Federal Register

[Docket No. FAA-2011-1231; Directorate Identifier 2011-NM-088-AD; Amendment 39-17418; AD 2013-08-01]

Airworthiness Directives; The Boeing Company Airplanes

ACTION: Final rule.

Figure 1, Fastener Removal of the Retainer Support on the Left Thrust Reverser Half

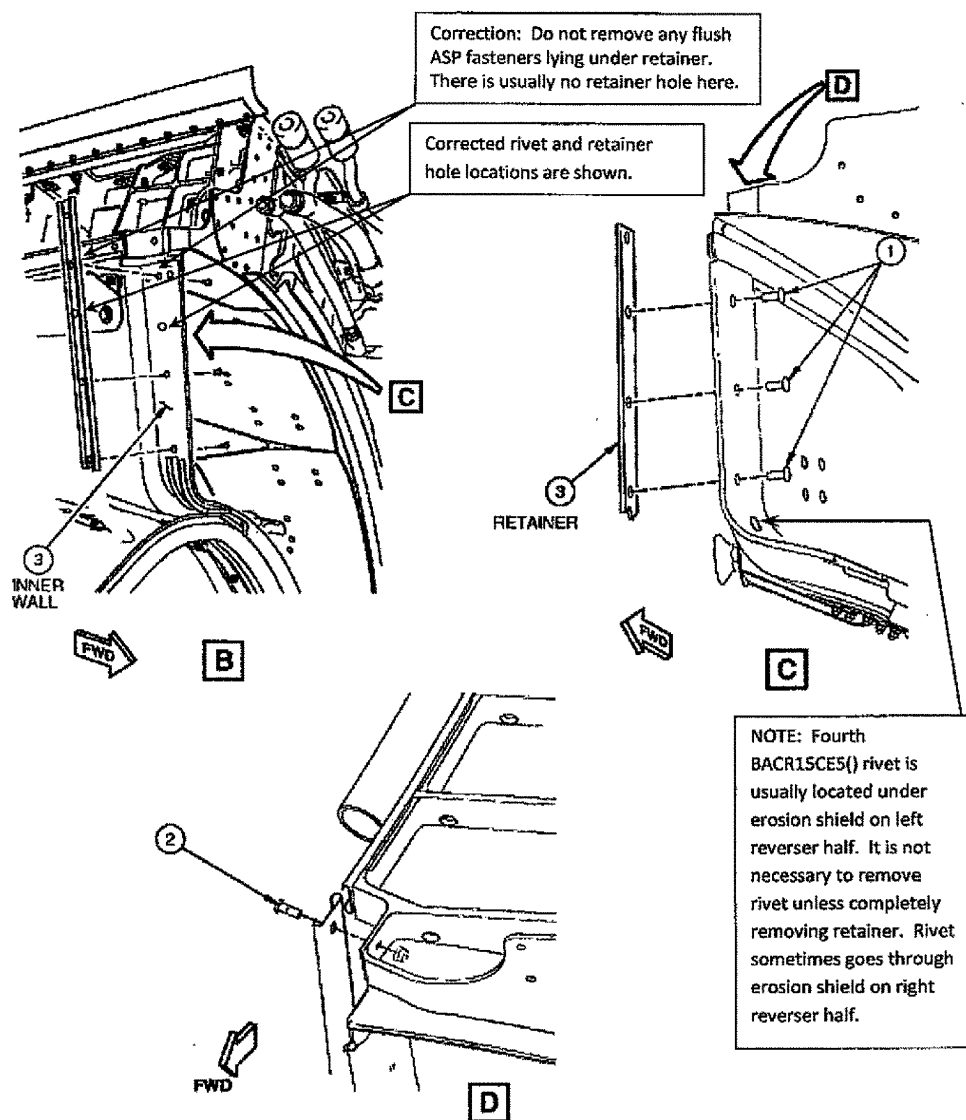
- Figure 10, Sheet 3 of 3: Note row (a) of the table shown in Figure 10, incorrectly refers the reader to "(a)" instead of Note row (b).
- Figures 6, 7, 15, and 16, all Sheet 2 of 3, all View B: These illustrations show the top fastener to be removed in the center of three fasteners in order to remove the retainer. However, these three fasteners are adjustable sustained preload (ASP) fasteners that do not require removal for this action. View B also incorrectly shows the location of the top rivet hole, which is actually below the row of ASP fasteners. These errors in those figures affect the actions specified in paragraph (g)(2) of this AD. The other instructions in the figures are correct.

(2) Figures 1 and 3 of this AD, titled “Fastener Removal of the Retainer Support on the Left (Right) Thrust Reverser Half,” have View B showing the top fastener in the center of three adjustable sustained preload (ASP) fasteners. That top fastener does not require removal in order to remove the retainer. The figures in this AD point to the correct information for those fasteners.

To clarify the correct actions for paragraph (g)(2) of this AD, we have added paragraph (h) to this AD to describe these differences, and Figures 1 through 4 of this AD to show the correct fastener and rivet hole information.

Figure 2, Installation of the New Bracket behind the Retainer Support on the Left Thrust Reverser Half

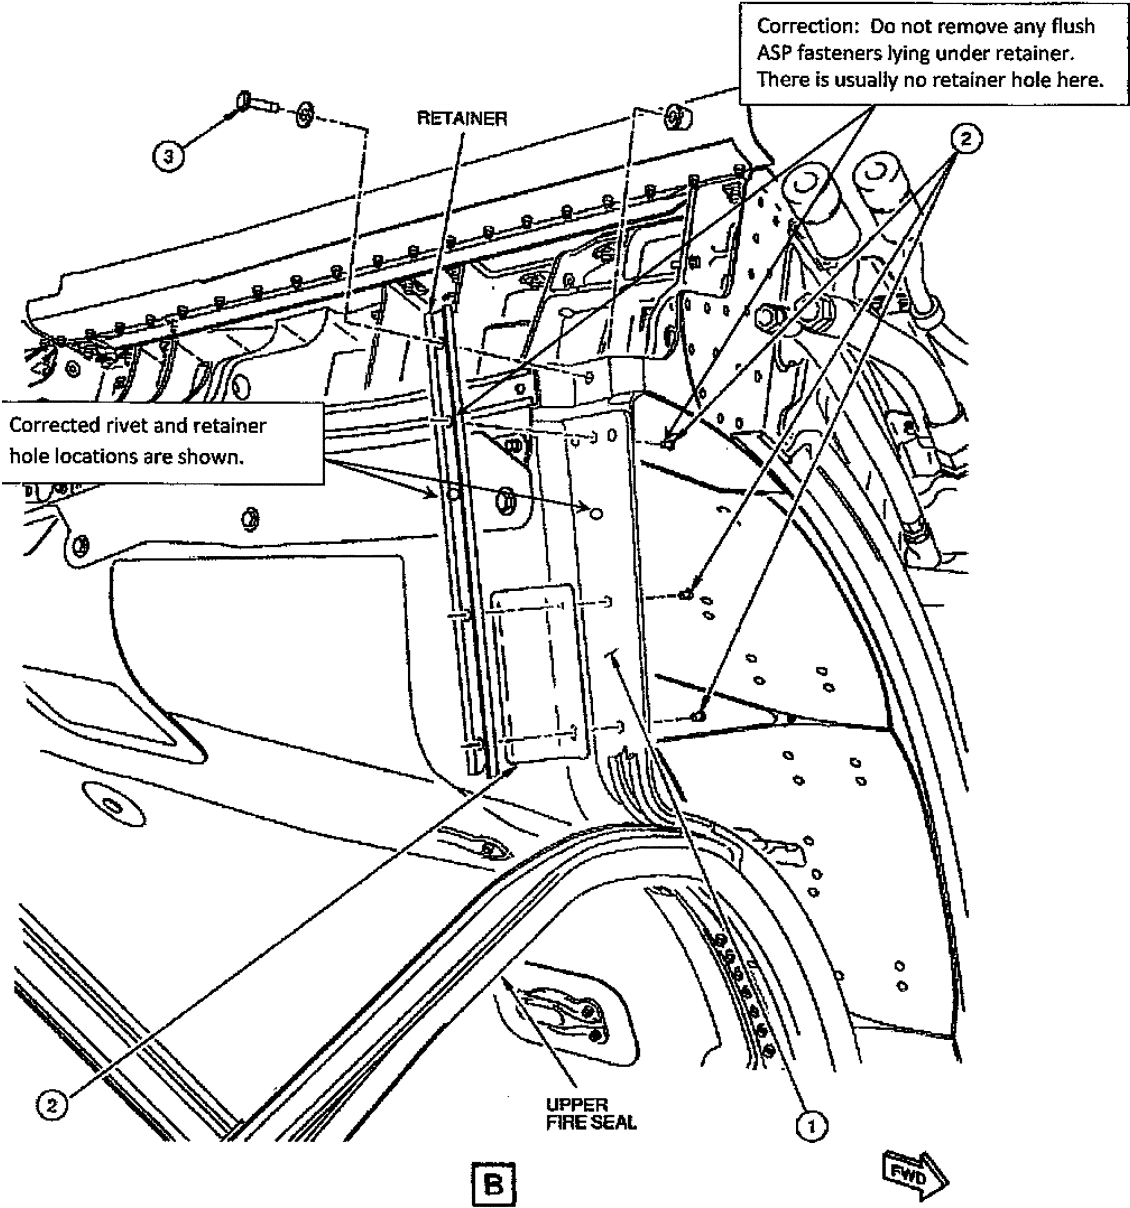
(3) Figures 2 and 4 of this AD, titled “Installation of the New Bracket behind the Retainer Support on the Left (Right) Thrust Reverser Half,” have View B showing the top rivet hole. That rivet hole is actually below the row of three ASP fasteners. The figures in this AD point to the correct information for those rivet holes.
